ADDENDUM NO. 4

Project:
VOL. 1 & 2
REYNOLDSBURG CITY SCHOOLS
L.F.O. ATHLETIC & ECO LAB PROJECTS
7244 East Main Street
Reynoldsburg, OH 43068

Addendum No.4
Vol. 1 & 2
Reynoldsburg City Schools
L.F.O. Athletic & Eco Lab Projects

| SKETCH NUMBER C-SK02 | |

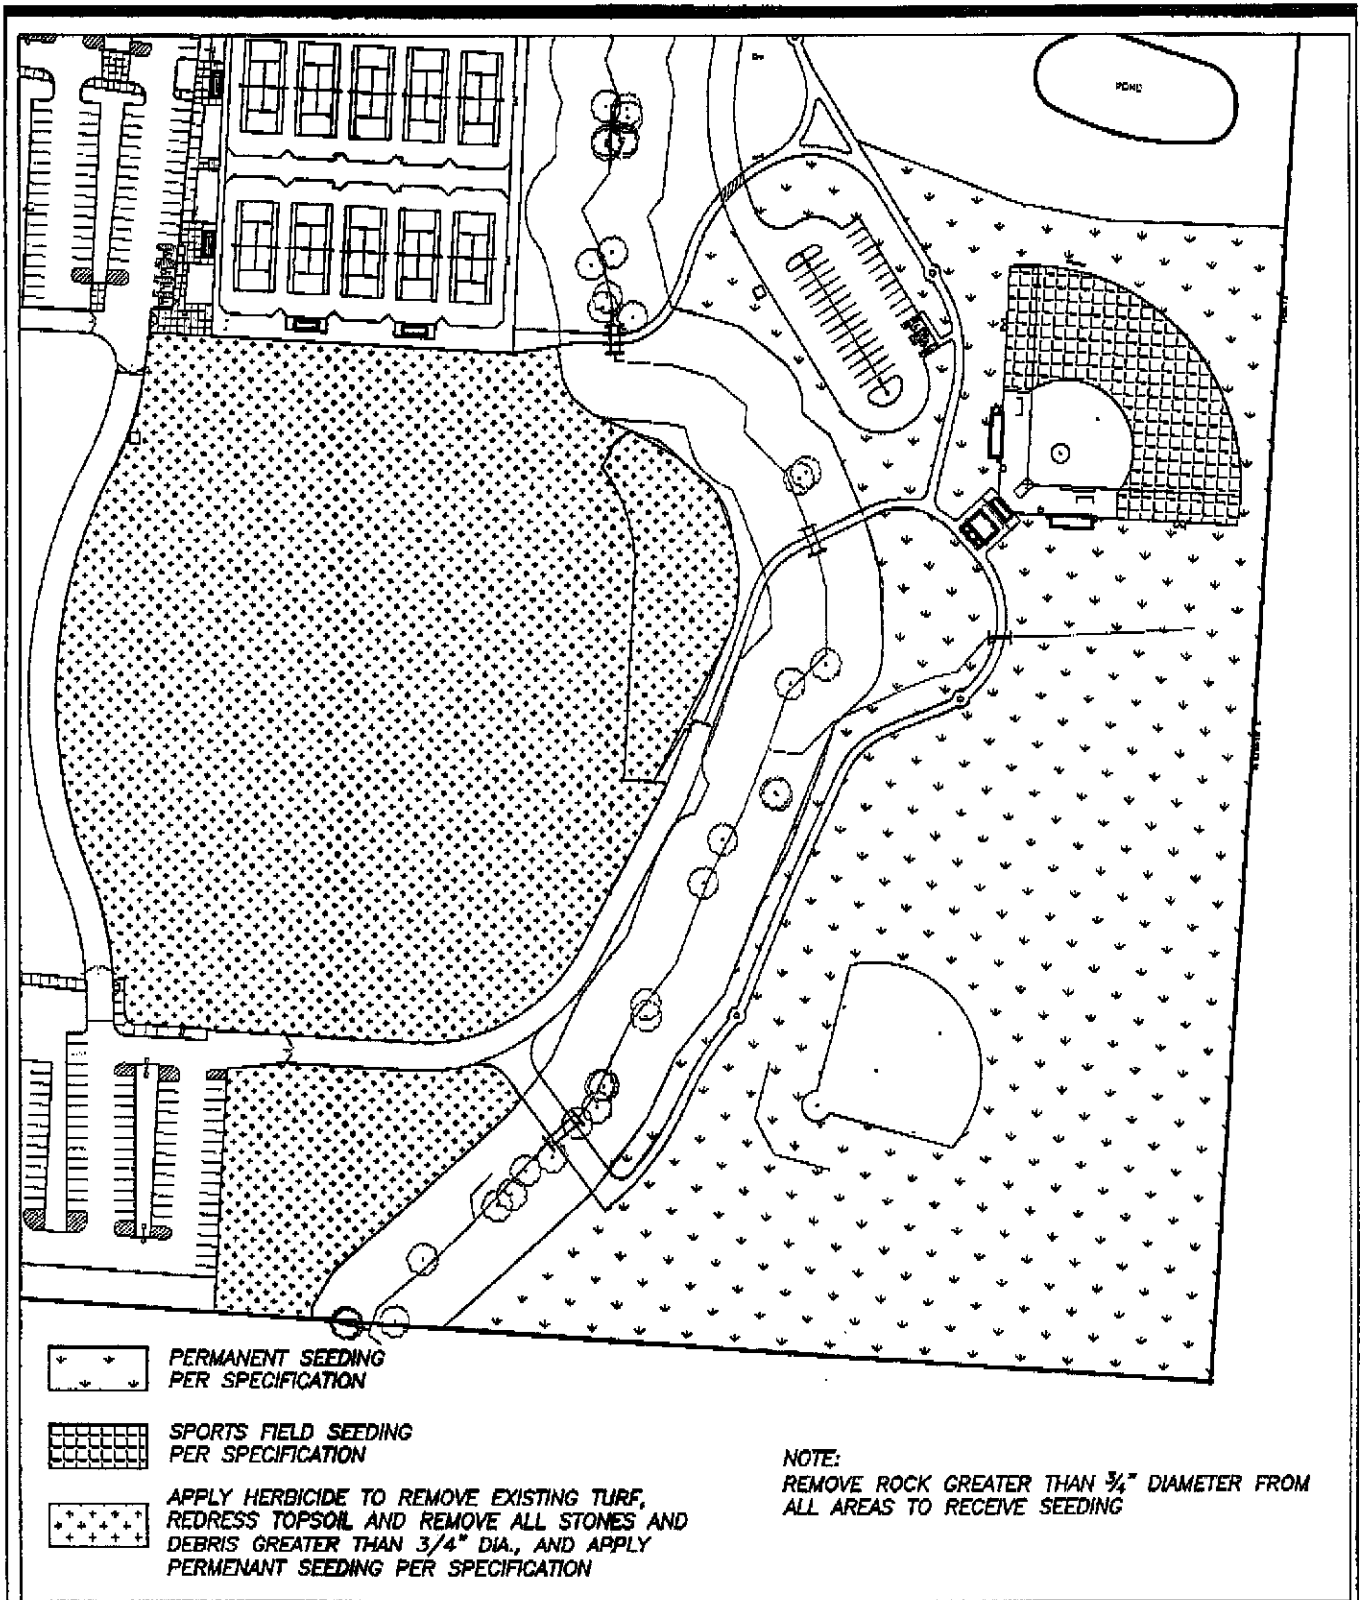
b. Is this seed mix the Sports Field Seed Mix and what are the seeding limits?

Plans call for all graded areas to be seeded. Since four types of seed mixes are in the specifications which seed if for the areas and what are the seed limits?

b. See C-SK02 for limits

PERMANENT SEEDING
PER SPECIFICATION

SPORTS FIELD SEEDING
PER SPECIFICATION

APPLY HERBICIDE TO REMOVE EXISTING TURF,
REDRESS TOPSOIL AND REMOVE ALL STONES AND
DEBRIS GREATER THAN 3/4" DIA., AND APPLY
PERMANENT SEEDING PER SPECIFICATION

NOTE:
REMOVE ROCK GREATER THAN 3/4" DIAMETER FROM
ALL AREAS TO RECEIVE SEEDING
